Product/Process Change Notice (PCN)

PCN Number: PCN_PeSHFU_20250618

Affected Series: WP-SHFU

Affected Part Number: 7461383

- Pictures & dimensions

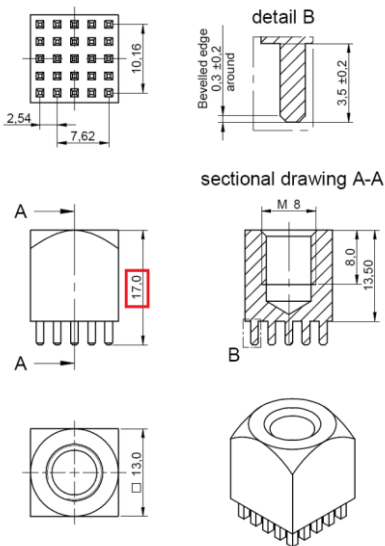
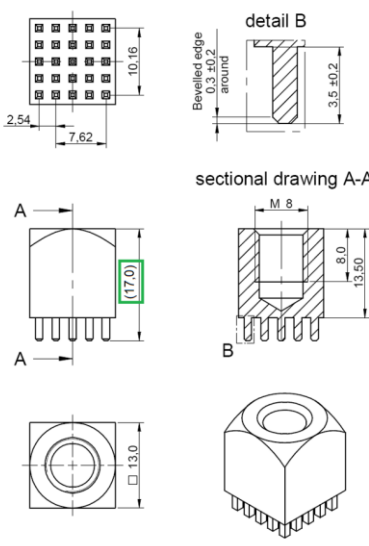
Due to an improvement of the production capability, Würth Elektronik eiSos will change the packaging from carton case to carton tray. The new carton will change the "single packaging quantity" (SPQ) and the "carton packaging quantity" (CPQ). The data sheet will be adjusted accordingly due to a technical, dimensional correction.

Before Change		After Change	
Carton Case (SPQ)	Shipping Carton (CPQ)	Carton Tray (SPQ)	Shipping Carton (CPQ)

Dimensions (LxWxH):	Dimensions (LxWxH):	Dimensions (LxWxH):	Dimensions (LxWxH):
108.0 x 85.0 x 65.0 mm	300.0 x 200.0 x 115.0 mm	274.0 x 171.0 x 15.0 mm	300.0 x 200.0 x min. 115.0 mm Height varies depending on the component due to two-part carton.
